To: Chair and Members of Rothesay Planning Advisory Committee
From: Brian L. White, MCIP, RPP
Director of Planning and Development Services
Date: Tuesday, November 30, 2021
Subject: Rezoning - 41 Unit Apartment Building – (Highland Avenue & Hillcrest Drive)

An application from Luke Moffett and Sean Hall to rezone 6751.79m² (1.67 acres) of land (see Map 1) off Highland Avenue and Hillcrest Drive from Single Family Residential – Large Serviced Zone [R1a] to the Multi-Unit Residential Zone [R4]) subject to a development agreement, in order to develop a 41 unit apartment building while retaining the two existing single family dwellings 2 & 4 Hillcrest Drive (PIDs 00444885, 00444877, 30346308, 30187629).

Figure 3 - Proposed Site Plan (41 unit apartment building and 2 single-family dwellings)

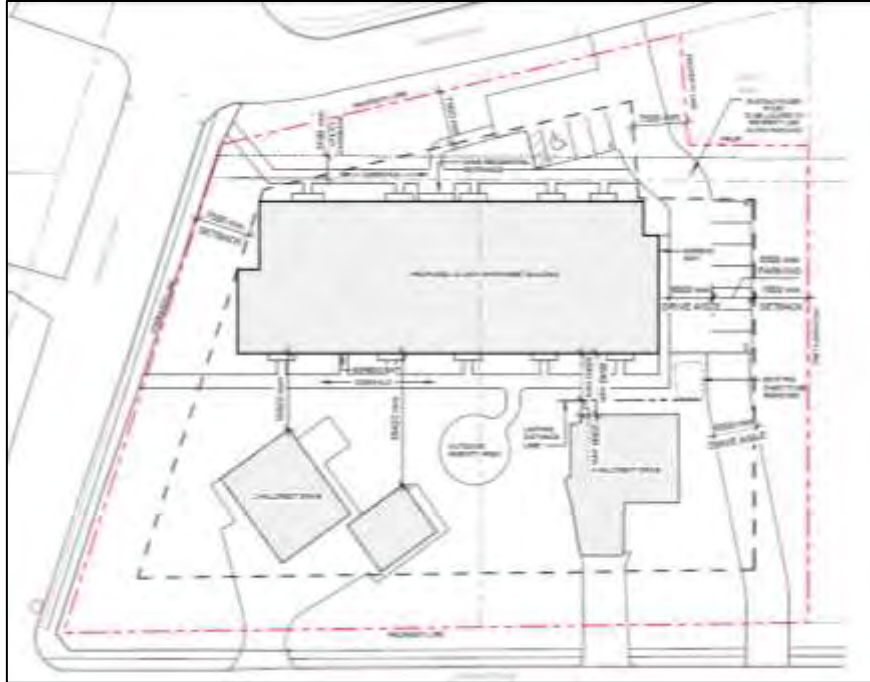
Best practices in town planning suggest that when considering residential infill of higher density that it is important to provide a transition in scale to adjacent smaller houses. Sites with higher-density zoning are often located along major streets where new development is intended to be concentrated. Good design would also transition the density to medium density at the rear, which would then abut lower-density zoning and houses. It is a fundamental design principle that in such residential infill situations, larger building volumes should be concentrated along the major street, with smaller buildings toward the rear.

The applicant's proposal is not a good example of how infill high density residential can be positioned next to single-family homes. Furthermore, the proposal conflicts with Municipal Plan Policy HDR-2 which describes the types of housing envisioned within High-Density areas. Policy HDR-2 allows within the High-density Residential designation, a mix of housing of types where the dominant form is an apartment or condominium dwelling. Other compatible uses may be permitted in the High-density designation without amendment to the Municipal Plan, including but not limited to parks, municipal facilities, public utilities, clustered residential housing, and attached dwellings. The policy does not contemplate low-density single-family dwellings as a compatible land use. Conversely, the "Central Park" condominium development (52-54 Hampton Road) is a good example of the correct interpretation and implementation of policy HDR-2, in that the high-density buildings are located next to Hampton Road and the medium density garden home duplexes transition to the single-family homes on Hillcrest.

- A. PAC Hereby TABLES the application to rezone land off Highland Avenue and Hillcrest Drive from the R1a zone to the R4 Multi-Unit Residential Zone pending a revision of the proposed development to reduce the density of the project, revision of the architectural style of the project to reinforce the general character of the area and to remove the existing low-density dwellings in accordance with the Municipal Plan designation of the property for high-density uses.

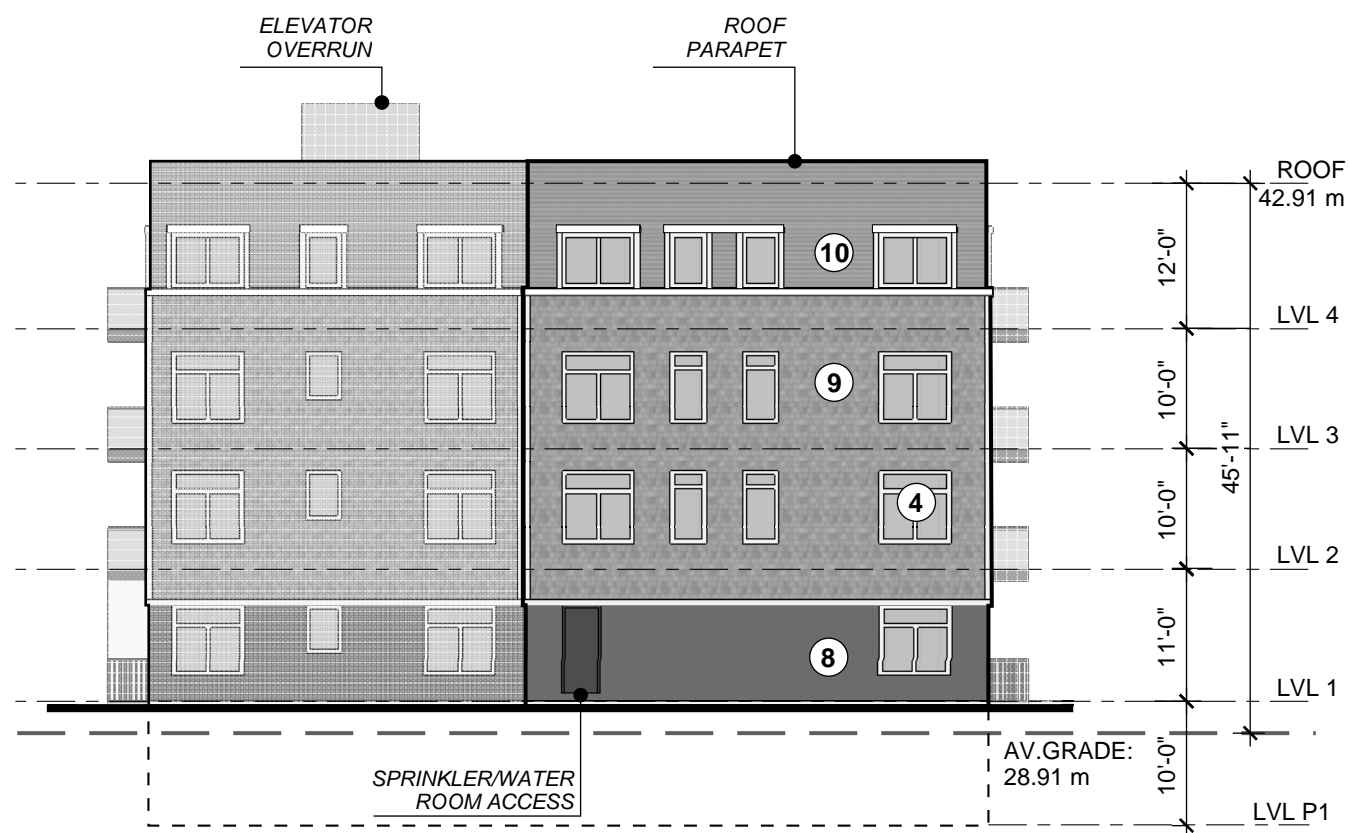
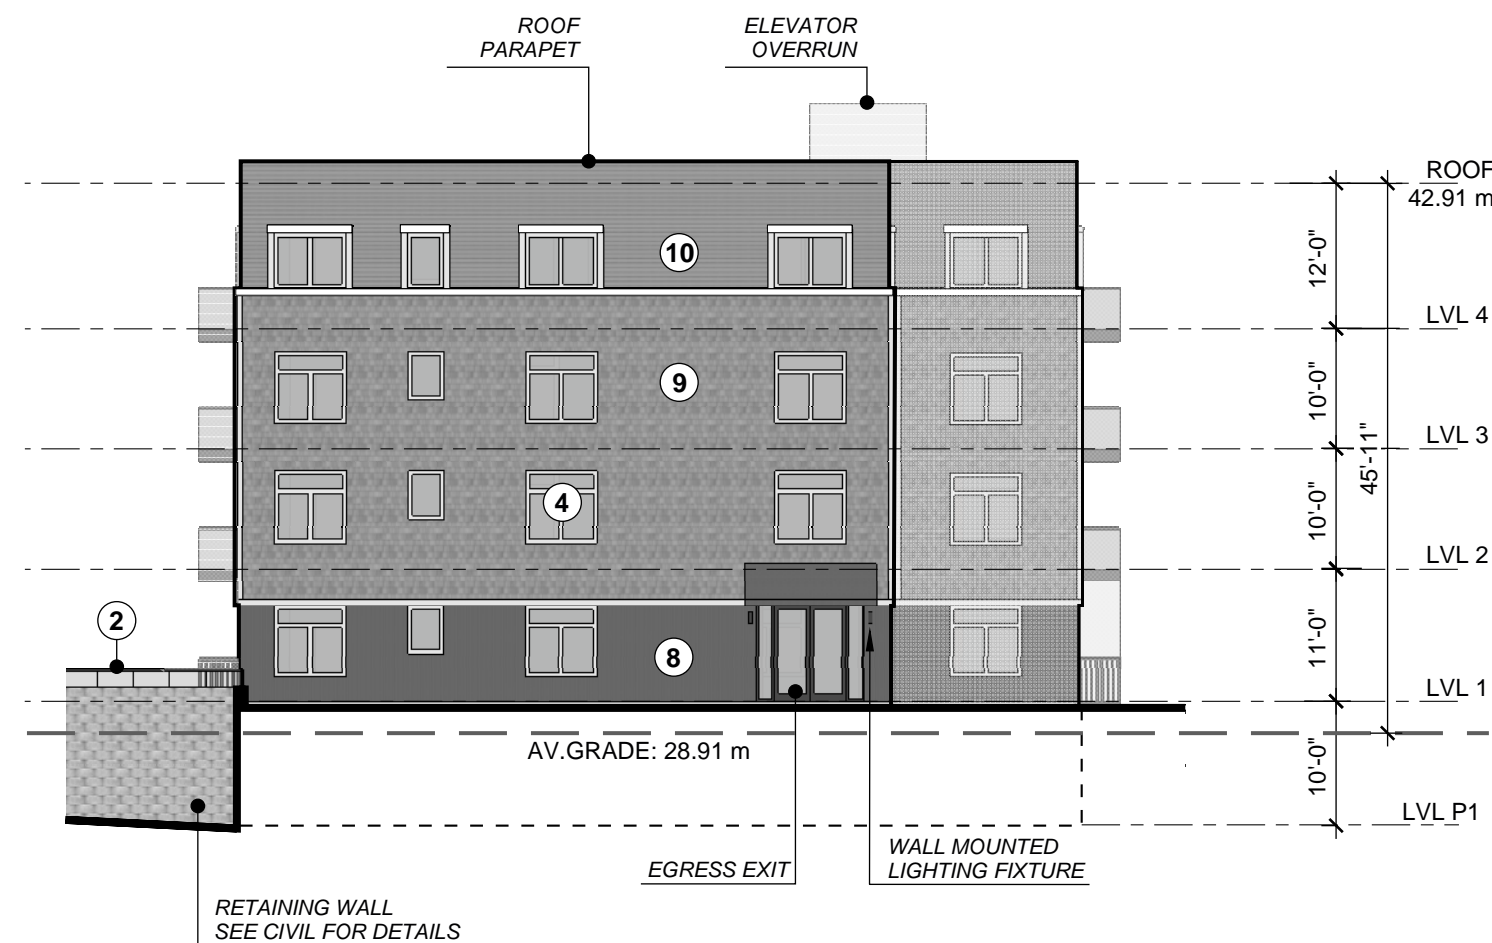
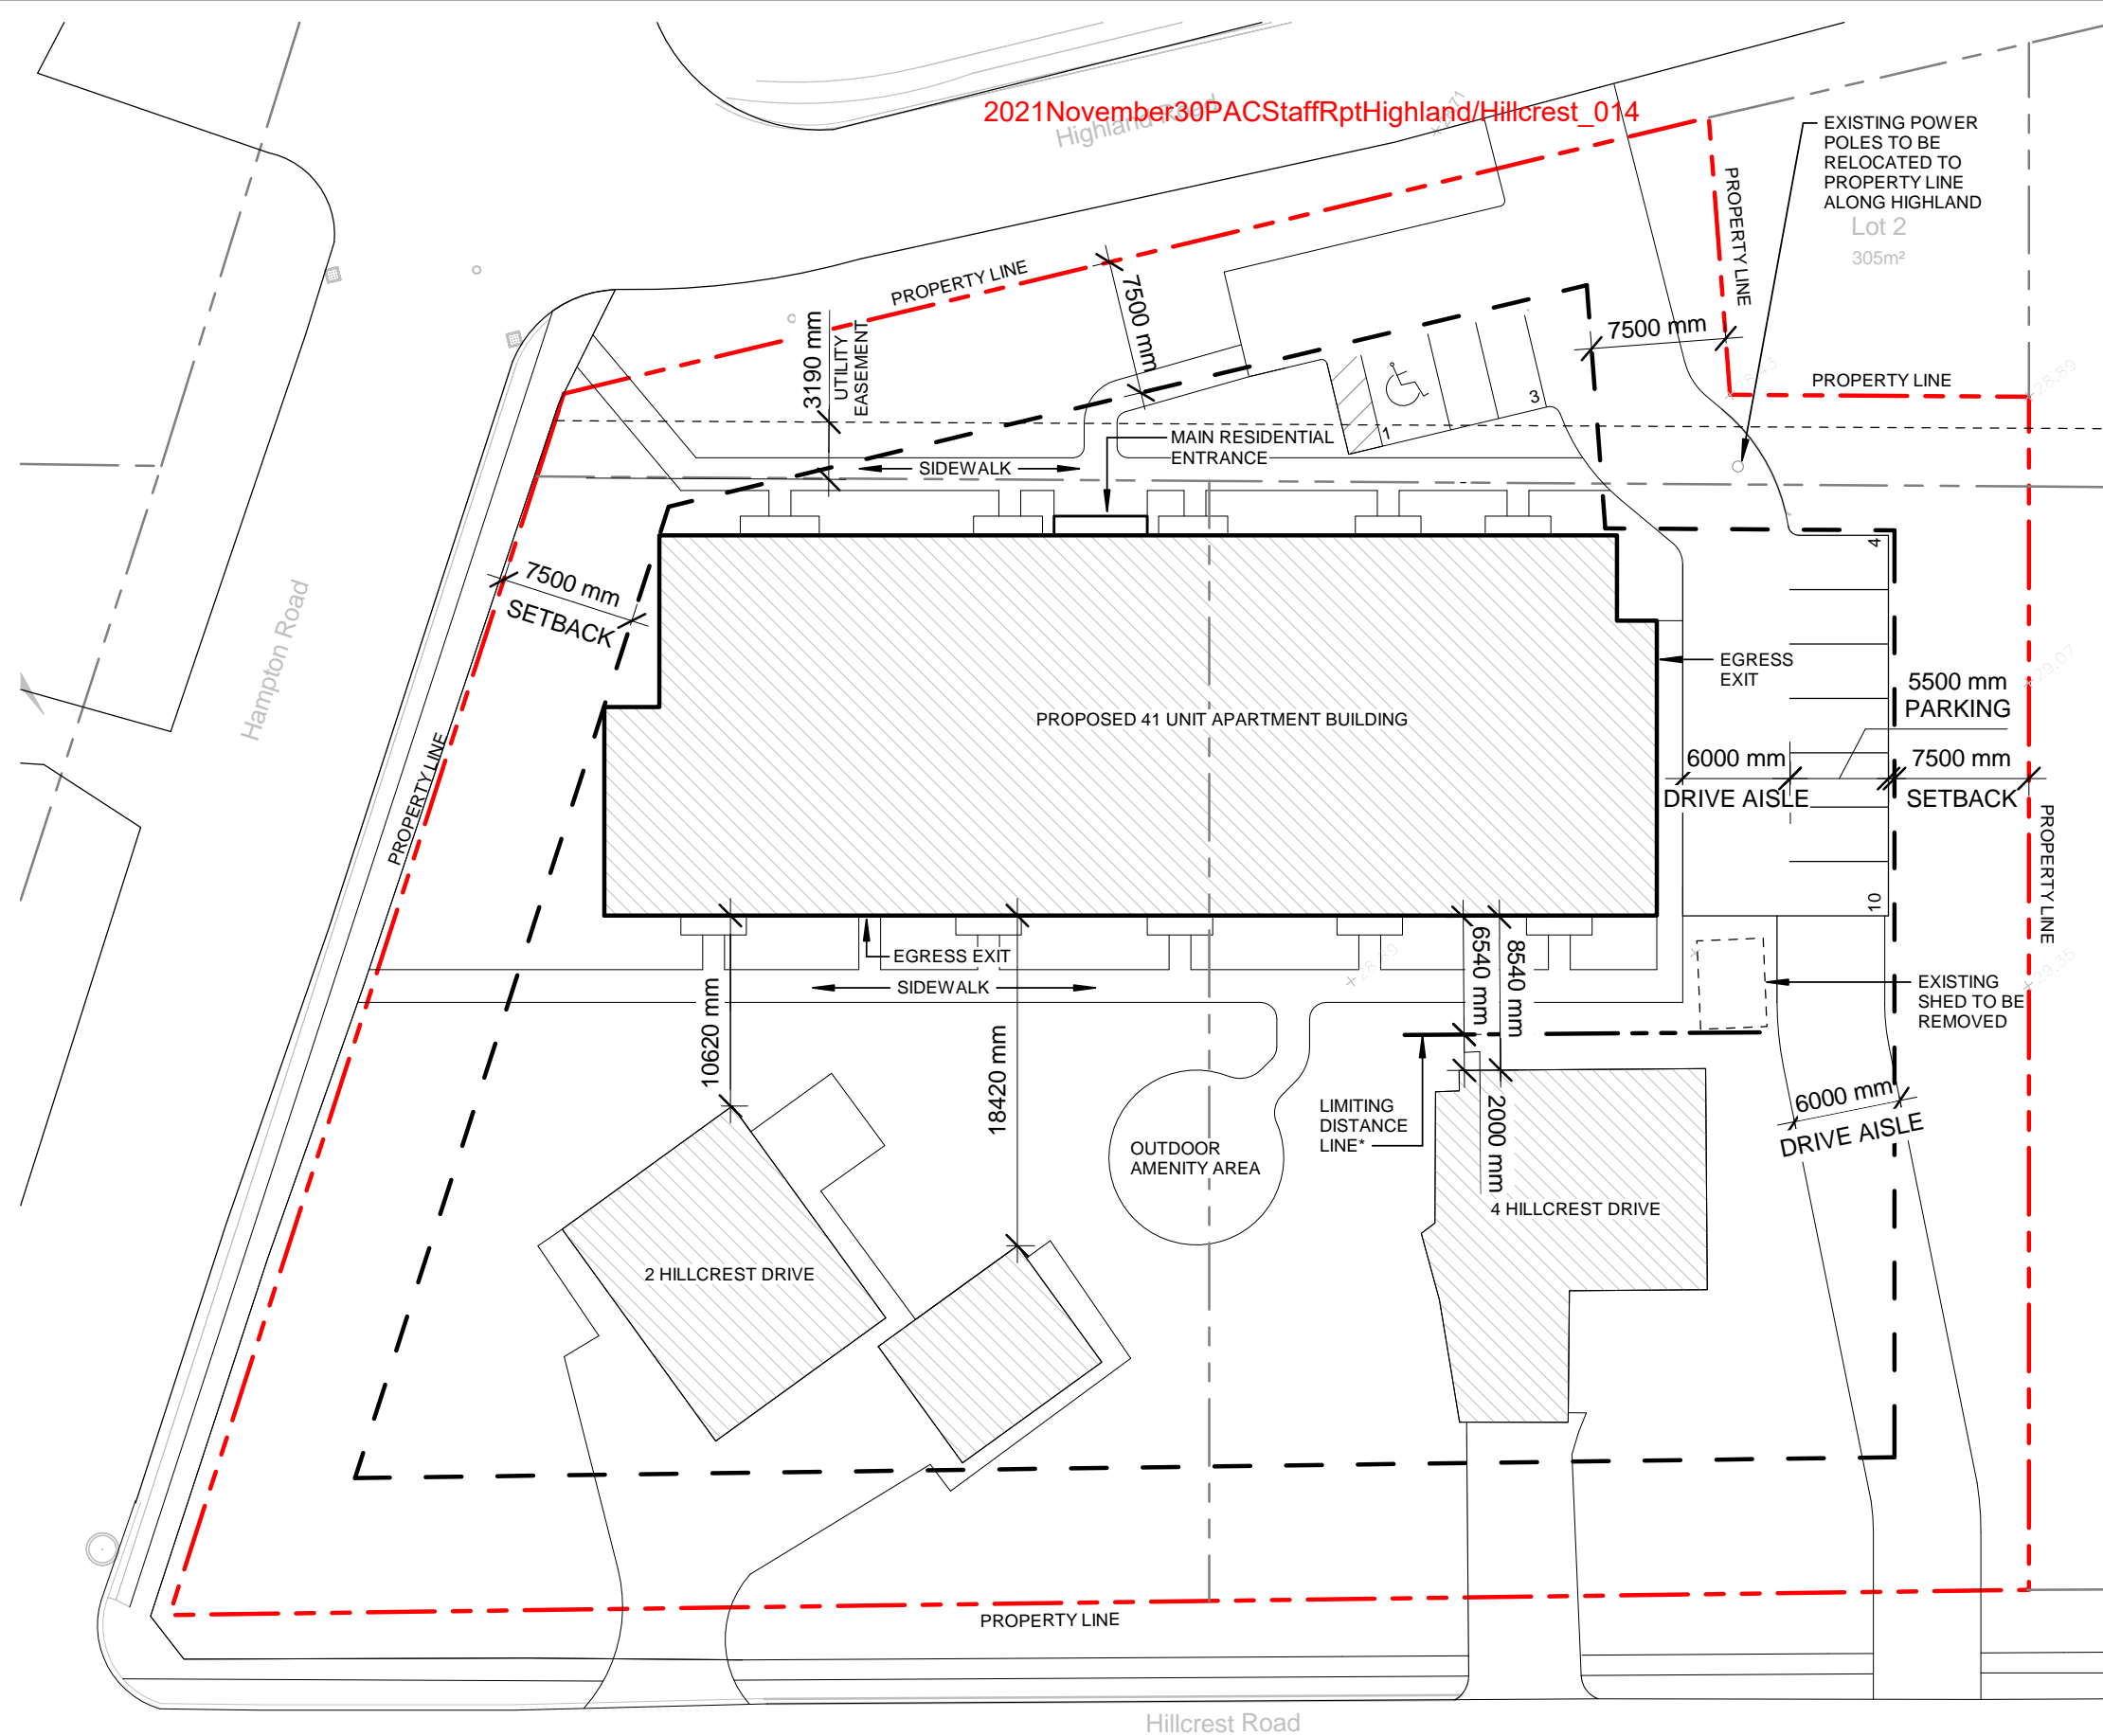
Architectural style is a very important factor when considering proposals that would change the existing land use, neighbourhood scale, density, and character. Staff support the value of encouraging residential infill development along Hampton Road in those designated high-density residential areas; however, the proposed development when viewed in contrast to its neighbours appears to be uncharacteristic of the area. The homes and larger buildings in this area reflect a more traditional building style and Staff believe that it is important that new buildings have an architectural style that is deferential to the neighbourhood. For example, in order to protect the established character of the area Council did, in the consideration of the 52-54 Hampton Road condominium project, require specific architectural requirements (peaked roof, cedar shingles, etc.).

Staff are concerned that the proposed development is not contextually appropriate. In fact, the building design closely reflects a design proposed by the same developer in a commercial designated area of Rothesay off Chapel Road. Earlier this year, on September 13, 2021, Council approved a 48-unit apartment building for the same developers on Chapel Road. The proposed Chapel Road building, albeit larger and with a few minor variations, has nearly the identical architectural character and building form. That building in a commercial area of Rothesay is appropriate; however, the developer's proposed building design in this location is not appropriate.

Staff promote and celebrate architectural innovation, and encourage context sensitive design that will advance the architectural excellence for infill development in Rothesay. Staff believe that well designed infill projects can augment, rather than detract from Rothesay's mature neighbourhoods. Regrettably, Staff do not believe the proposed four-story flat roof "modern aesthetic" building relates well to this specific neighbourhood. Staff's hope is that the developer and their architects can present a building that will strengthen the local character of this neighbourhood. Staff observe the one of the major architectural features found in this local neighbourhood context is that of large gabled roofs with pediments². (See figure 6)
